PLATE D6-4

POWER RESOURCES, INC.
 20 BOX 610 BLENKOW, WY
 HIGHLAND URANIUM PROJECT
 WEST HIGHLAND AMENDMENT
 OIL WELL, GROUND WATER &
 SURFACE WATER LOCATION MAP
 CONVERSE COUNTY, WYOMING
 SCALE: 1"=200' DATE: 02/29/94 DRAWN: JKT CHECKED: JKT
 REV: 0000 NO.

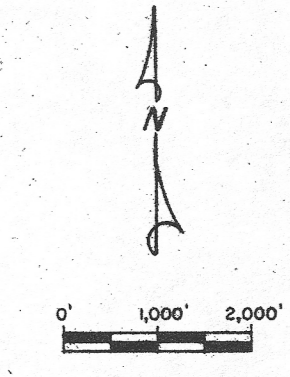
This North-South line should be located 300 ft. east along the center quarter section line of Section 20.
